January 5, 2025

Re: Surfrider comments on the San Diego DRAFT Coastal Resilience Master Plan

Ocean Beach - Dog Beach & Beachfront (Pier)

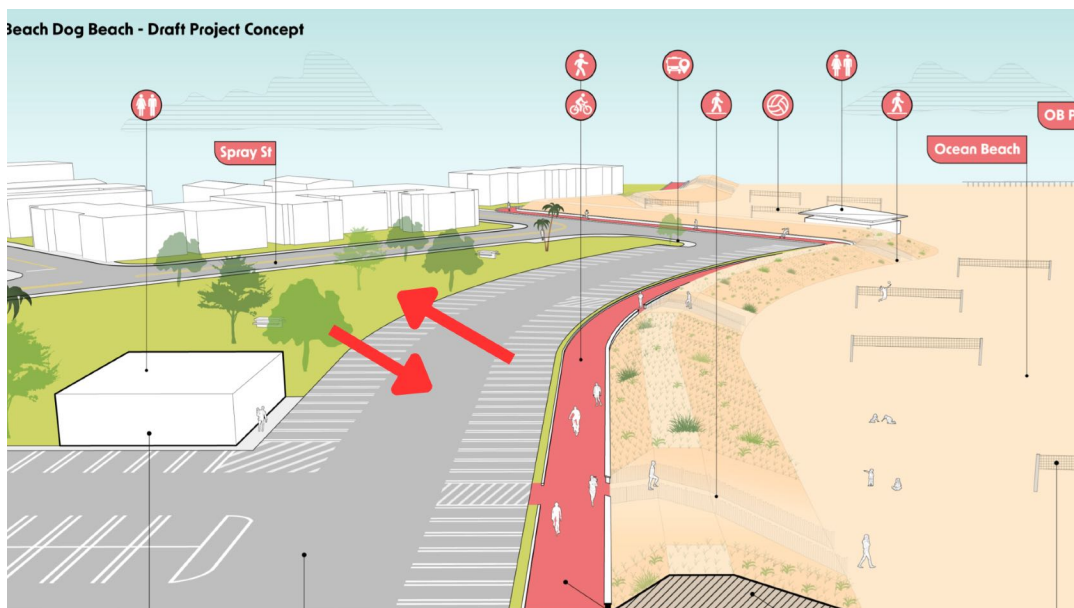
Surfrider supports the permanent dune installations across the back beach at both locations. While they may require occasional maintenance, a permanent dune installation would provide similar benefits to the City's annual winter berm program without the need to build, then flatten them, each year.

For Dog Beach, we're most supportive of the *Project Concept D-2, Resilient Relocation*, because it includes relocation of the bathroom which will eventually become threatened by SLR. And although it does not speak to coastal resilience, the

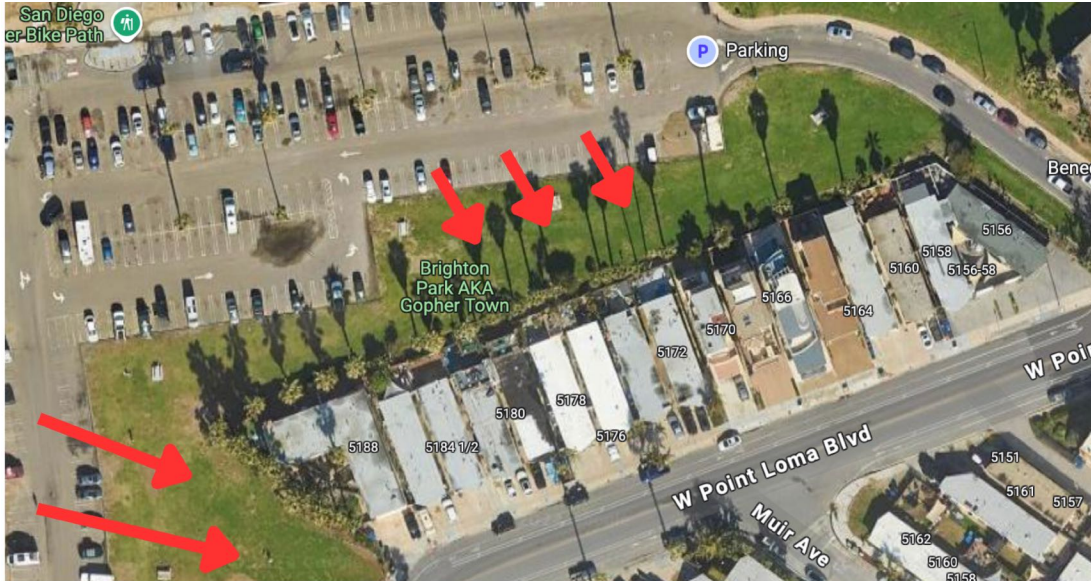
A more resilient project for Dog Beach could borrow the same concept used on our preferred design for La Jolla Shores, *Project Concept B-2: Reconfigured Park*, by moving the park seaward and replacing it with the lost parking spaces. Doing so would create an attractive beachfront park that is unobstructed by parked cars. A floodable park would also add an additional layer of resilience, by protecting the infrastructure behind it from coastal storm surge. Relocation of the bathroom could be harmonized with this larger overhaul. Lastly, reorienting the parking lot now precipitates a future project that will inevitably need to occur once sea levels rise to a certain level.

Swapping the park with the parking lot would increase resilience to flooding, while replacing an underutilized park with an attractive beachfront park

Brighton Park is underutilized due to its bad location; why not study moving the parking lot into its footprint to create more beach and/or beachfront green space?
